# Access Compliance Report

## Public Rights-of-Way

### (Curb Ramps)

Intersection ID: 9052	Main Street: JEFFERSON_DAVIS_ST	Cross Street: MORETZ_AV	Location: S
ADA ID: 5A78647A4B5E	Ramp Type: Para	Initial Pass/Fail: Fail	Overall Compliance: No
Codes/Mitigation Info/Possible Solution		Field Measurements/Component Compliance	
Severity Score: 36.25

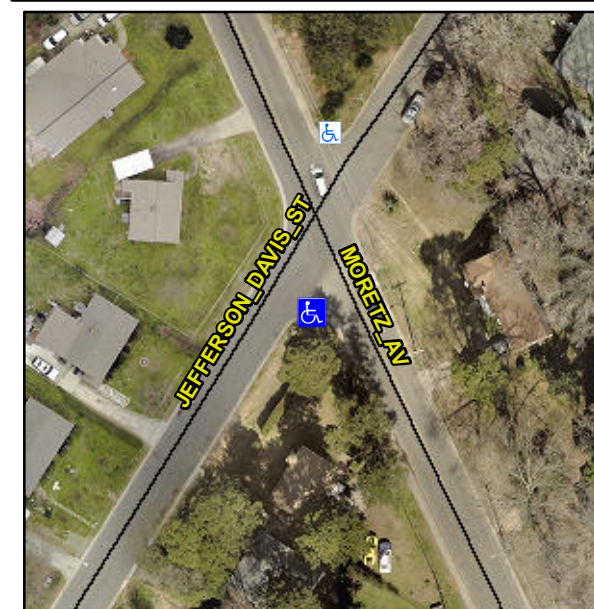
**RT RP < 5%, NO RT SW**

**R304.5.1, R304.5.3**

**Remove & Replace Entire Ramp.**
